Executive Director's Recommendation

Commission Meeting: January 5, 2017

PROJECT Square Guidelines Squares 378 and 379 935 Pennsylvania Avenue, NW Washington, DC	NCPC FILE NUMBER P7713
SUBMITTED BY National Capital Planning Commission	NCPC MAP FILE NUMBER 1.25(38.00)44456
REVIEW AUTHORITY 40 U.S.C. § 6702 and Memorandum of Agreement, § V, 61 Fed. Reg.41789, 41791 (August 12, 1996)	APPLICANT'S REQUEST Approval of Final Square Guidelines for transmittal to GSA
	PROPOSED ACTION Approve Final Square Guidelines as requested and transmit to GSA
	ACTION ITEM TYPE Presentation

Figure 3: Illustration of the Pennsylvania Avenue 1:1 Initial Height Ratio

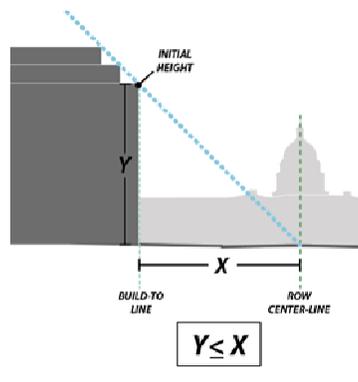
- **11.a-c. (Height of Development on Sq. 379 and Sq. 378)** – No substantive revisions. The Guidelines within each sub-section were reorganized/reordered and language revised to be consistent with defined terms and supplemented with illustrations to improve clarity.

New Illustrations

- The maximum building height shall not exceed 135 feet, inclusive of penthouses.
 - The initial height of buildings fronting directly on Pennsylvania Avenue shall not exceed a 1:1 ratio to ensure that the vista of the U.S. Capital remains unobstructed. As illustrated in Figure 3, the height of the initial vertical rise of the building wall shall not exceed the horizontal distance measured from the centerline of Pennsylvania Avenue, on center with the U.S. Capitol, to the build-to line along the Avenue.
